Access Compliance Report

Public Rights-of-Way

Intersection ID: 18496	Main Street: MICHAEL_BAKER_PL	Cross Street: SELWYN_AV	Location: SE
ADA ID: B6B34E24D9F0	Ramp Type: Para	Initial Pass/Fail: Fail	Overall Compliance: No
		Severity Score: 12.5

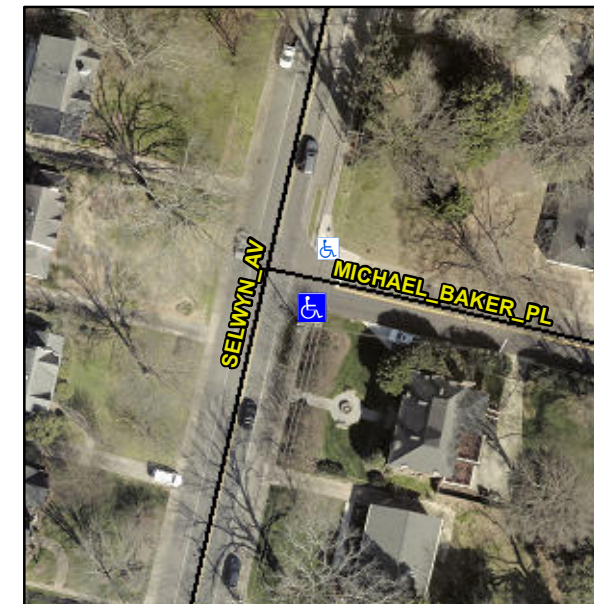
R304.3.2

Compliance	Description	Data	Compliance	Description	Data
N/A	Ramp Length LT (in)	N/A	N/A	Ramp Length RT (in)	76.0
N/A	Ramp Width LT (in)	N/A	Yes	Ramp Width RT (in)	73.0
N/A	Ramp Slope LT (%)	N/A	No	Ramp Slope RT (%)	8.8
N/A	Ramp XSlope LT (%)	N/A	Yes	Ramp XSlope RT (%)	1.3
N/A	Landing Length (in)	N/A	N/A	DWS Provided?	N/A
N/A	Landing Width (in)	N/A	N/A	DWS Contrast?	N/A
N/A	Landing Slope (%)	N/A	N/A	DWS Length (in)	N/A
N/A	Landing X Slope (%)	N/A	N/A	DWS Full Width?	N/A
N/A	Landing Curb? (Y/N)	N/A	N/A	DWS Offset (in)	N/A
N/A	Shared Landing?	N/A			
N/A	Gutter Ponding?	N/A	N/A	Gutter Slope (%)	N/A
N/A	Gutter Lip Ht (in)	N/A	N/A	Gutter X Slope (%)	N/A
N/A	Painted X Walk1?	No	N/A	Painted X Walk2?	N/A
	X Walk 1 Direction	To N		X Walk 2 Direction	N/A
N/A	X Walk 1 Width (in)	N/A	N/A	X Walk 2 Width (in)	N/A
	X Walk 1 Slope (%)	6.3		X Walk 2 Slope (%)	N/A
	X Walk 1 X Slope (%)	5.9		X Walk 2 X Slope (%)	N/A
N/A	Ramp inside XWalk1?	N/A	N/A	Ramp inside XWalk2?	N/A

Remove & Replace Entire Ramp.
